Technical Service Bulletin

01 MIL on (P1297, P2187, P2279), oil leaks

01 12 44 2015505/10 March 16, 2012. Supersedes Technical Service Bulletin Group 01 number 11 – 37 dated November 23, 2011 for reasons listed below.

Figure 1. The crankcase ventilation pressure regulating valve and turbo intake pipe is circled here.

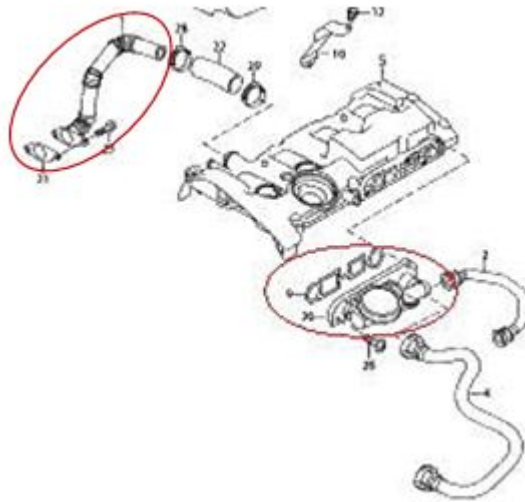
The conditions described may be caused by a malfunction of the crankcase ventilation pressure regulating valve or turbo intake pipe (Figure 1), resulting in excessive vacuum or excessive pressure being applied to the engine crankcase.

Improved crankcase pressure regulating valve and turbo intake pipe.

Install improved pressure regulating valve and/or turbo pipe according to table below.
